Access Compliance Report

Public Rights-of-Way

(Curb Ramps)

Intersection ID: N/A	Main Street: PAISLEY_ABBEY_LN	Cross Street: KELBURN_LN	Location: SW
ADA ID: 1ED88B2A894C	Ramp Type: Perp	Initial Pass/Fail: Fail	Overall Compliance: No
Codes/Mitigation Info/Possible Solution		Field Measurements/Component Compliance	
Severity Score: 10

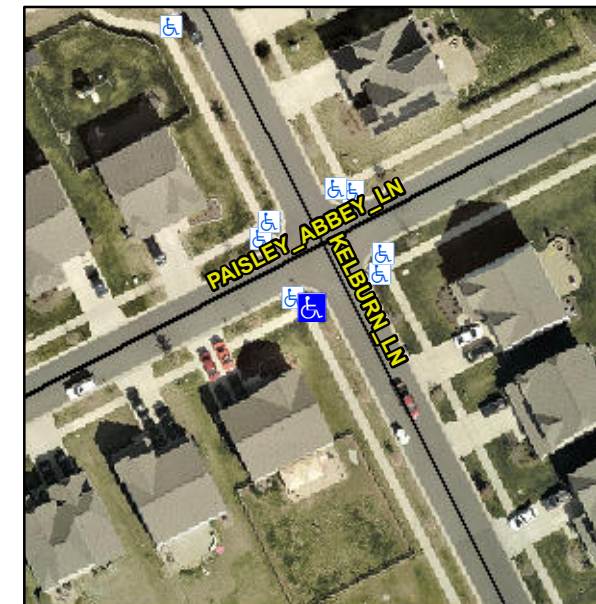
Not Found, R304.5.1, R304.5.3

Compliance	Description	Data	Compliance	Description	Data
N/A	Ramp Length (in)	104.0	Yes	Ramp Slope (%)	7.8
No	Ramp Width (in)	41.0	No	Ramp XSlope (%)	2.6
N/A	Flare Type LT	N/A	N/A	Flare Type RT	N/A
N/A	Flare Slope LT (%)	N/A	N/A	Flare Slope RT (%)	N/A
N/A	Flare Traversable LT?	N/A	N/A	Flare Traversable RT?	N/A
N/A	Landing Length (in)	N/A	N/A	DWS Provided?	N/A
N/A	Landing Width (in)	N/A	N/A	DWS Contrast?	N/A
N/A	Landing Slope (%)	N/A	N/A	DWS Length (in)	N/A
N/A	Landing X Slope (%)	N/A	N/A	DWS Full Width?	N/A
N/A	Landing Curb? (Y/N)	N/A	N/A	DWS Offset (in)	N/A
N/A	Shared Landing?	N/A			
N/A	Gutter Ponding?	N/A	N/A	Gutter Slope (%)	N/A
N/A	Gutter Lip Ht (in)	N/A	N/A	Gutter X Slope (%)	N/A
N/A	Painted X Walk1?	No	N/A	Painted X Walk2?	N/A
	X Walk 1 Direction	To NE		X Walk 2 Direction	N/A
N/A	X Walk 1 Width (in)	N/A	N/A	X Walk 2 Width (in)	N/A
	X Walk 1 Slope (%)	0.4		X Walk 2 Slope (%)	N/A
	X Walk 1 X Slope (%)	3.4		X Walk 2 X Slope (%)	N/A

Remove & Replace Entire Ramp.
